# MANDATORY SERVICE BULLETIN

## MSB 42-109/2

Installation of a start assist relay for ECU start phase monitoring.

## WI-MSB 42-109

D60-9224-30-05, Schematic, Starter Engaged Input to ECU

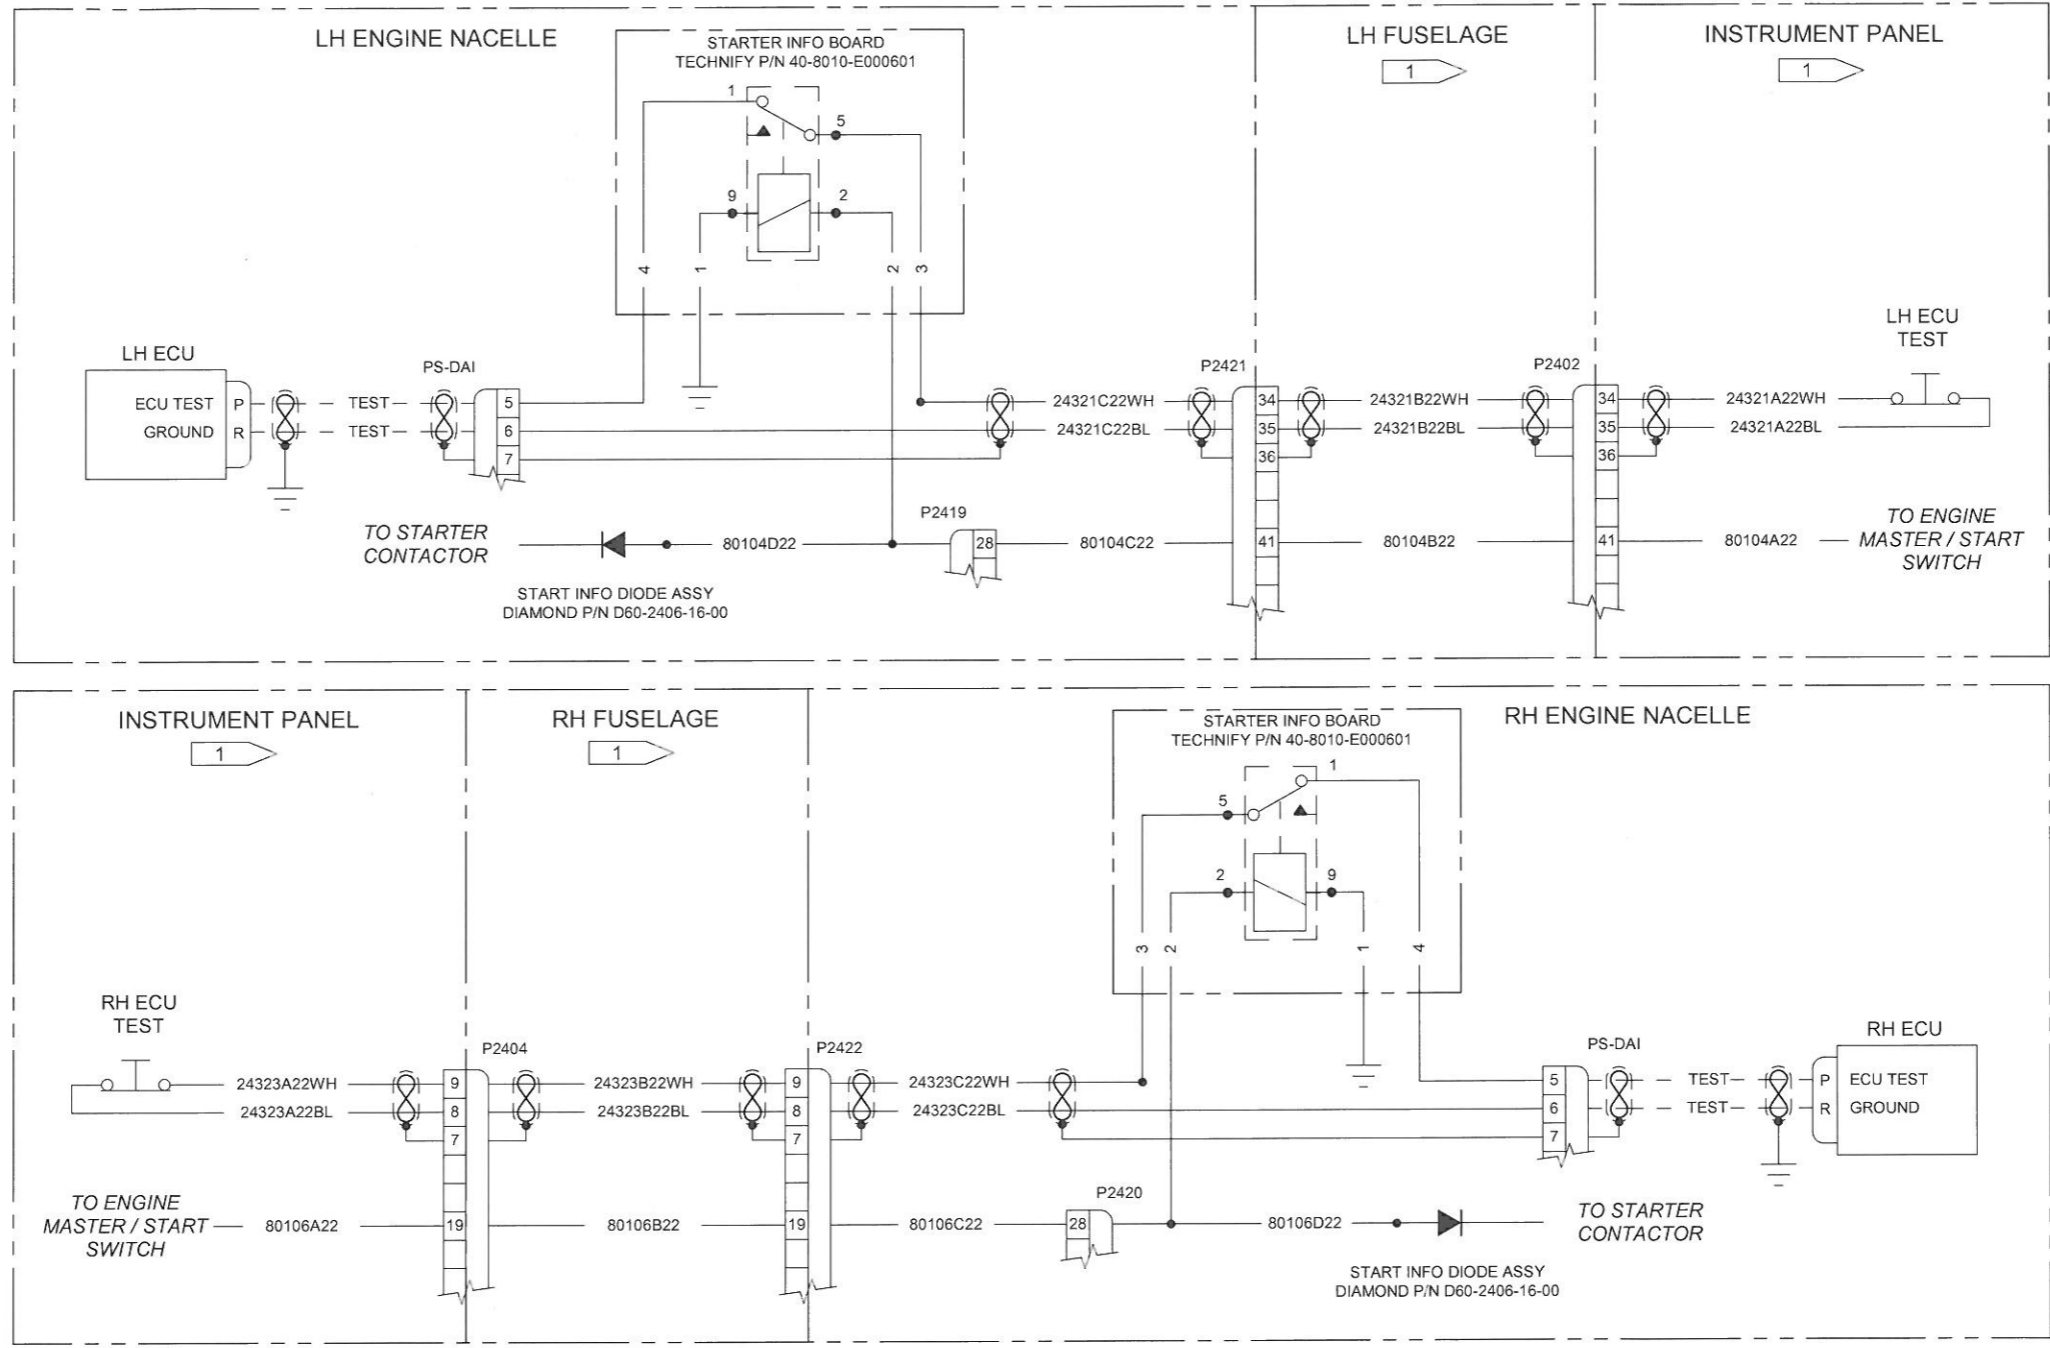
REVISION					
REV	SH	ZONE	DESCRIPTION	DATE	APPROVAL
-	01	ALL	MÄM 42-843 FIRST RELEASE	15.10.14	SEE ÄM
A	01	ALL	MÄM 42-843/a P/N of Technify Starter Info Board corrected	28.11.14	SEE TB
